VALIDATION REPORT

Project Title	Composting Project in Santa Catarina
Version	02.0
Report ID	2793.11.A.0

Report Title	Validation Report of Composting Project in Santa Catarina
Client	Sustainable Carbon – Projetos Ambientais Ltda
Pages	70
Date of Issue	06 th -February-2014
Prepared By	TÜV Rheinland do Brasil Ltda. (On behalf of TÜV Rheinland (China) Ltd.)
Contact	Address: Rua Líbero Badaró, 293, São Paulo - SP - Brazil. Telephone: +55 11 3514-5791 Email: nathaly.jo@br.tuv.com / Website: www.tuv.com
Approved By	Mr. Henri Phan
Work Carried Out By	Mr. Sebastián del Valle Rosales, ex-Team Leader Ms. Kamala Devi Muniandy, Team Leader Ms. Nathaly Marie Jo, Auditor Ms. Tais Gennari Luciano, Auditor Mr. Yi Liu, Technical Expert Ms. Danae Diaz, Technical Reviewer

Figure 1: Location of cities where the farms are situated. (Source: Google Maps)

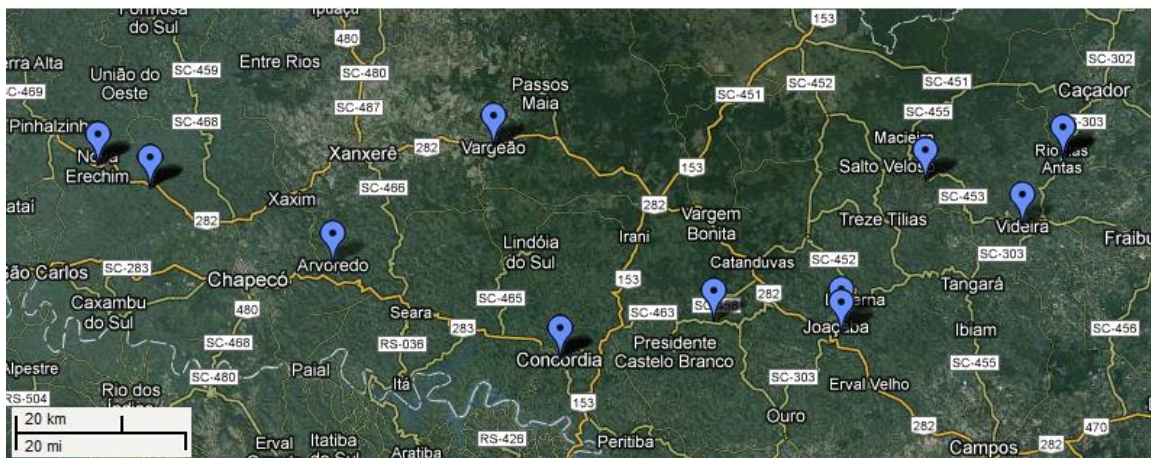
4.3 Project boundary					
4.3.1 Does the VCS PD correctly describe the project boundary? <i>Provide Yes/No answer. And amend the Tables 2 and 3 if needed.</i>	/ 1 / (1.9, 2.3)	DR	CAR 5: Please insert Nova Itaberaba city in the map on page 8 of PD / 1 / (please also insert the subtitle “Figure 1: ...”).	CAR 5	CLOSED

CAR 5: Please insert Nova Itaberaba city in the map on page 8 of PD / 1 / (please also insert the subtitle "Figure 1: ...").	4.3.1	Figure 1 was revised to include Nova Itaberaba and to exclude Videira, since no farm included in the project is located in Videira.	All corrections were made on Figure 1 (page 8) of PD v. 02.1. CAR is CLOSED.
